Request for Information
RFI# 0575

Subject: Grading in Deck A East Entrance @ Loading Dock
Project: THE DOMAIN - Phase I
Address: 1450A Avenue Road
Austin TX 78746-1515
Phone: 512-473-2000 **Fax:** 512-473-2025
To: Jody Raymond
J. Raymond Architects
From: HCS&L, LTD
Consultant: Simon | Endeavor

GRAPHIC PLAN
 12.1.06

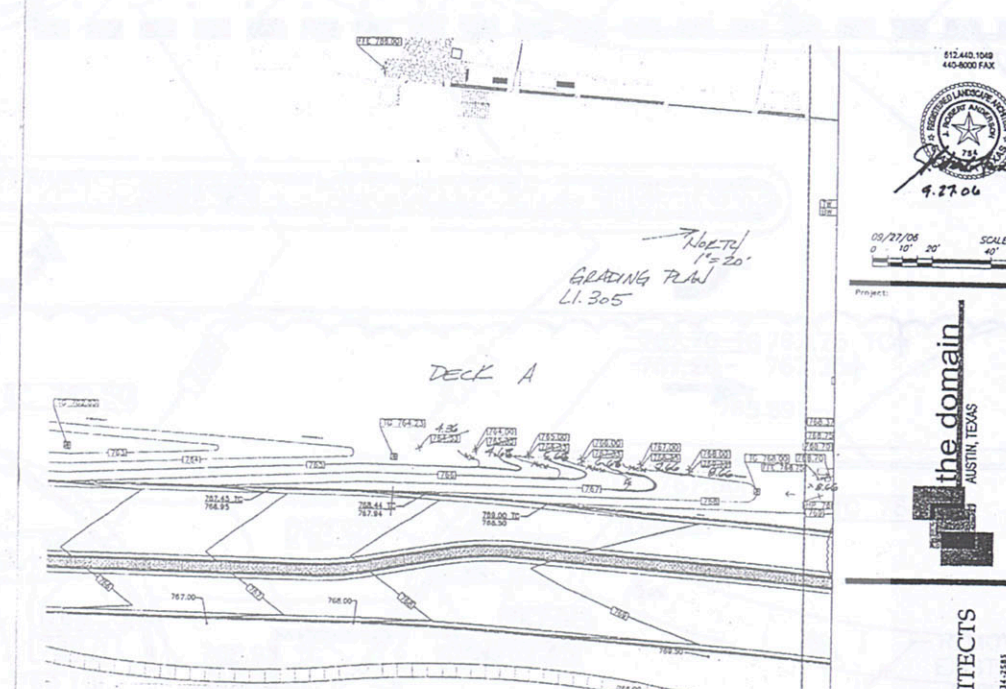
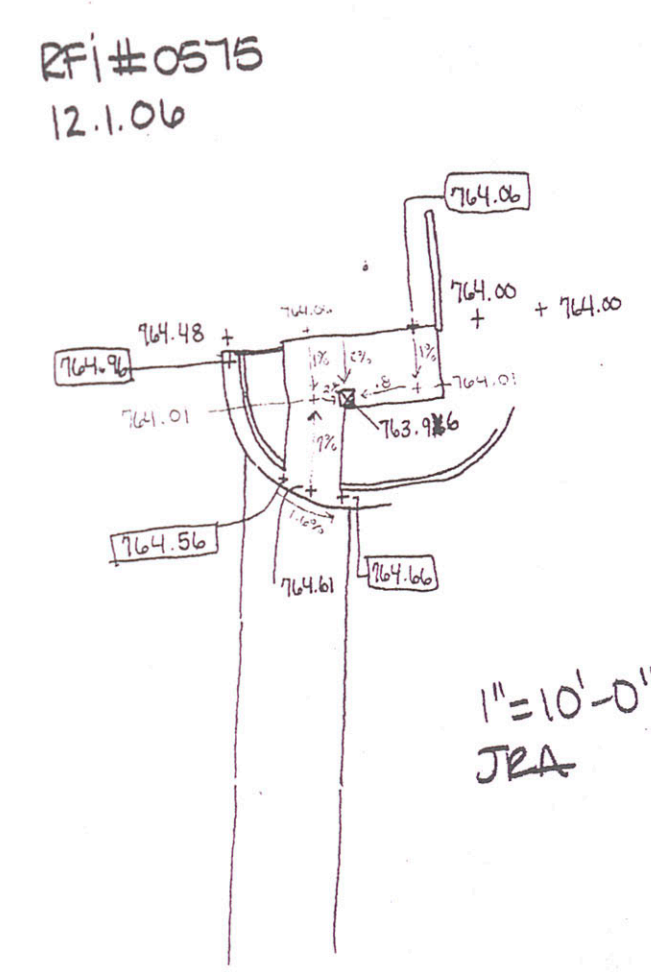
Request:
 Refer to the attached sketches / blow-ups of the area east of Deck A at the middle entrance.
 The grade elevations for the landscape grading plans and the Deck drawings do not match. Please provide clarification for actual elevations in the area. This area does not appear to have been graded and finished. Please advise.

Suggestion:
 Answer: ☐ Amend Elevation
 Hand-drawn and steps can be incorporated. See attached sketch. Note TO changes. JRA assumes a condition elevation above the existing of 744.00. We also assume there is no topographic step under the building as the RFI states that the surface elevation is 1.00' higher than the drawings stated FFE of 743.00.
